**BEFORE THE INDEPENDENT HEARING PANEL ON PROPOSED PRIVATE PLAN  
CHANGE 13 TO THE OPERATIVE HAMILTON CITY DISTRICT PLAN**

**IN THE MATTER** of proposed Private Plan Change 13 to the Hamilton City District Plan

Statement of rebuttal evidence of Sivakumaran Balachandran on behalf of the  
Waikato Racing Club Incorporated

Dated: 17 August 2023

**Figure 1: Proposed Design – Removal of Parking Spaces on Te Rapa Road Service Lane**

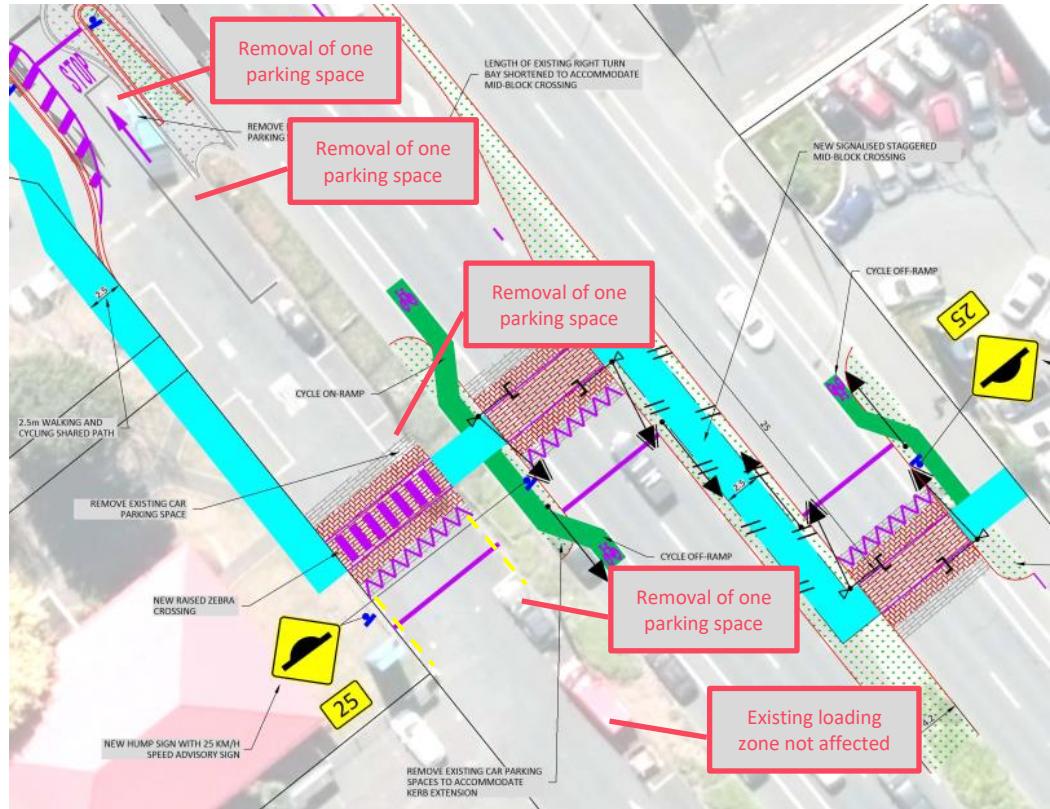
11. Mr Hall identifies that an 8 m gap currently exists on the northern side of the service lane between the on-street parking spaces. I disagree with Mr Hall that a raised safety platform (“RSP”) can be added within this 8 m gap without removing any car parking spaces for the following reasons:

- (a) The width of a RSP is approximately 7.25 m (with a flat section of 5 m) in accordance with the Regional Infrastructure Technical Specifications (“RITS”). This would mean that if the RSP is installed within the identified 8 m gap, the limit line prior to the zebra crossing will be positioned across an existing parking space on the northern side of the service lane. Parking is not permitted within 6m of a zebra crossing so this space will have to be removed.

- (b) No-stopping lines are also required to be marked for a minimum distance of 6 m prior to a zebra crossing. This is not shown in the concept drawings attached to the ITA or my primary evidence but will be required at detailed design stage.

12. I have provided a comparison inFigure 1 and Figure 2 which illustrate Mr Hall’s suggested solution (i.e. RSP within the 8 m gap) and the concept design in my primary evidence respectively. This effectively shows that there is no difference in the number of parking spaces (i.e., two) that must be removed to accommodate the RSP.

13. Therefore, I disagree that a RSP can fit within the existing 8 m gap without removing any parking spaces. PC13 proposes to remove approximately four parking spaces along the service lane: two near the intersection with Sir Tristram Avenue and two directly in front of Signature Homes. In my opinion, the benefits of removing these four car park spaces to achieve the proposed safety upgrades at the Te Rapa Road / Sir Tristram Avenue
